RECORD OF ACTION

Architectural Review Board

2. 48 S. High Street 24-130MPR

Minor Project Review

N. High Street Renovations

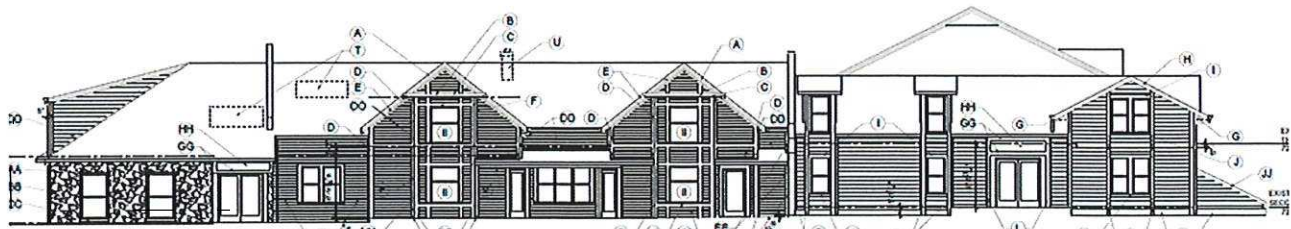
Ms. Holt referenced the above rendering of 72/84 North High Street to detail proposed renovations. The left side has new windows and doors and will retain the stone. The center portion has the signature feature box bay windows that are treated uniquely from the rest of that portion of the building. There are single hung windows, special trim detail and drop siding that will match the siding found underneath the plywood skin. This will be clad in 4-inch reveal lap siding. On the right
